SCHWEIZER SERVICE NOTICE

NOTICE NO. N-195

SUBJECT: INSPECTION OF MAIN TRANSMISSION ASSEMBLY, P/N 269A5175-11, -13, -15 and -17

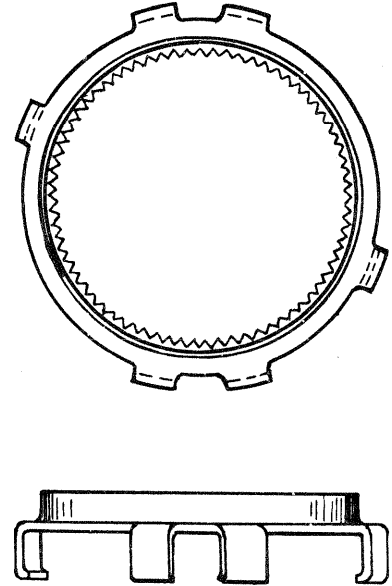
- a. Visually examine the pinion shaft lockwasher to determine if the correct washer has been installed. Detail "A" of this Notice shows a visual indication to identify the lockwasher.

- c. If the transmission is found to have the wrong lockwasher, P/N SL61W9, then continue with the disassembly and inspection as follows.
- d. Remove incorrect lockwasher and discard. Replace with new SL60W9 lockwasher

A picture of both the SL61W9 and SL60W9 Lockwashers is shown above in Detail "A". Note that the incorrect SL61W9 Lockwasher has 4 retract dimples on the surface as compared with the SL60W9 Lockwasher which is smooth on the surface. The SL60W9 is the correct Lockwasher.
